Lower Road Two-Way Streets and Cycleway 4 consultation

Summary Report

March 2020

Section 1. Lower Road (between Culling Road and Ann Moss Way)

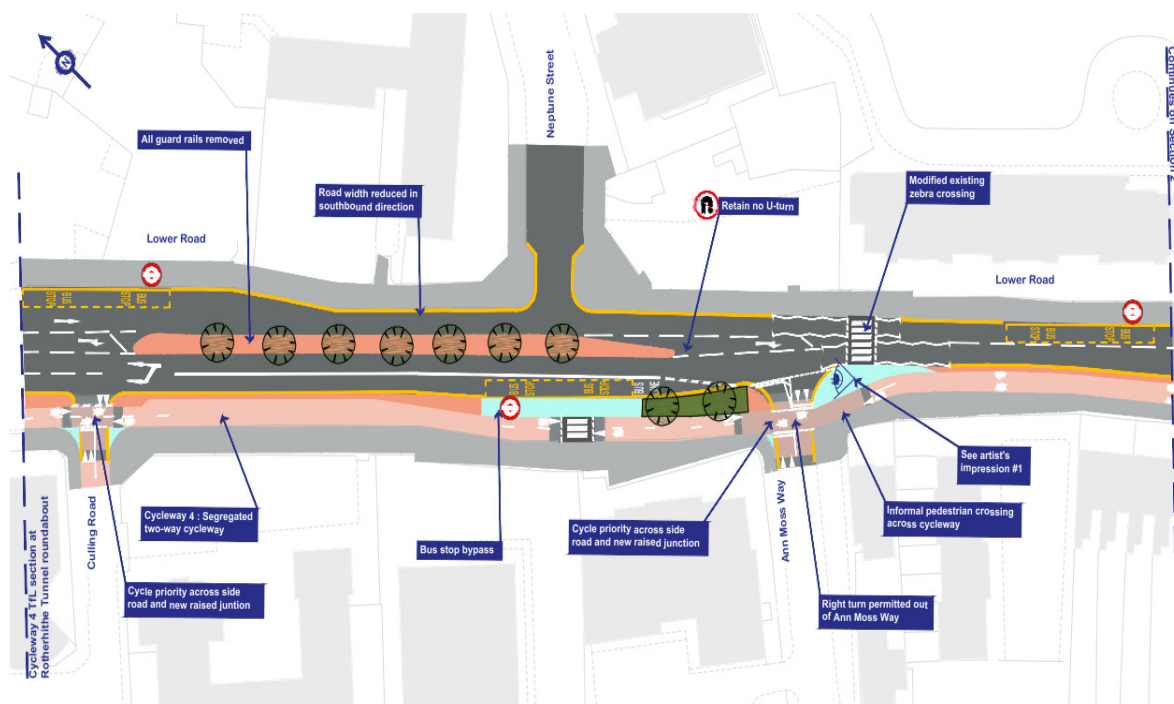
I support your plans, but the bus stop bypass will be dangerous to pedestrians and cyclists. It needs to be CLEARLY MARKED that cyclists have right of way, otherwise people will just walk out into the cycle path and get knocked down.

A mini zebra crossing across the cycle track to join the zebra crossing on the carriageway will make things clearer and safer for cyclists and pedestrians
Add a mini zebra across the cycle track that will link up with the zebra crossing across the general carriageway
Add mini zebra across cycleway to link to zebra across roadway, as seen on Cycleway 6.

Right turn from Ann Moss is dangerous and reason why this was stopped was due to a motorcyclist fatality-. It is noted that there will be no clear view when exiting due to the new trees being planted and as such oncoming traffic obscured

In addition, drivers leaving the street will have to check for northbound incoming traffic to stop at the same time than the bicycles in both directions and then repeat the process for southbound traffic and I question the waiting space for vehicles, especially trucks and large vans is sufficient to avoid accidents. Therefore, a yellow grid box is needed to have enough room for safety

The zebra crossing south of Ann Moss Way should be modified to provide cycle crossing facilities to and from the cycleway and, the pavement between the crossing and Neptune Street should be made shared-use, so that cyclists can get between Neptune Street and the proposed cycleway without interacting with live motor traffic.

More of a steep ramp up from Lower Road to Ann Moss Way - the artist's impression seems to show a very gentle slope

Flush segregation islands do not provide a true level of segregation and will not prevent motor vehicles intruding on the cycleway.

Section 2. Lower Road (between Surrey Quays Road and Gomm Road)

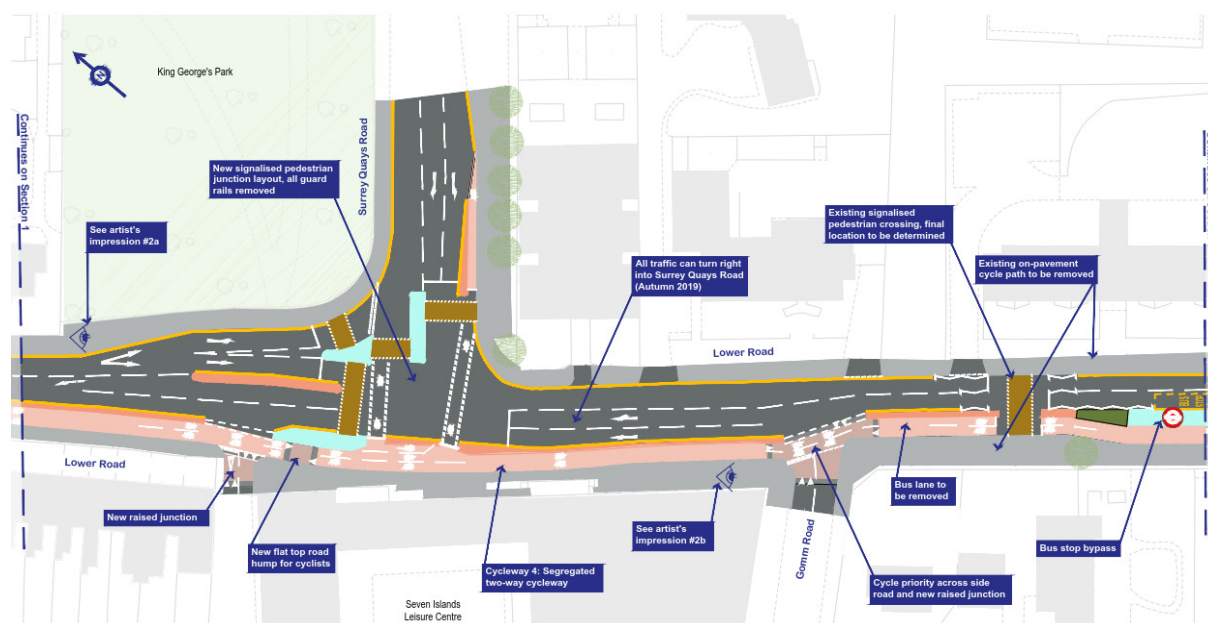
Please retain the pavement level cycle track on east side of Lower road until the site is redeveloped as this provides access to the ramp to access the shopping centre. Please provide space on the west side for those using the toucan crossing.

Add a formal crossing so pedestrians can get from the corner of the east side of lower road and north side of surrey quays road, over to the west side of lower road. Current plans look like they're dumped on a new pavement with no clear way to cross the new 2-way cycle path.

Agree crossing needs simplification
Disagree with cycle lane.
<p>Support, but other improvements are needed:</p> <p>Retain current yellow box junction to prevent motorists blocking the junction during peak times.</p> <p>Add a formal crossing so pedestrians can get from the corner of the east side of lower road and north side of surrey quays road, over to the west side of lower road. Current plans look like they're dumped on a new pavement with no clear way to cross the new 2-way cycle path.</p> <p>Pavement level cycle track on east side of Lower road should be retained until the site is redeveloped</p>

Your drawing shows "raised carriageway" features shaded pink where it appears cyclists may have priority / will believe they do when completing this questionnaire and these raised carriageway" features need to have road markings to indicate priority for pedestrians.

The crossing at Courthope House, why can't you decide the position? It can go at the entrance to Canada Water Masterplan Site alongside of the existing police station.

Can a wheelchair manoeuvre? As per TfL guidelines. 2.5M is too narrow. Does it provide a bus stop that protects passengers from the rain properly?
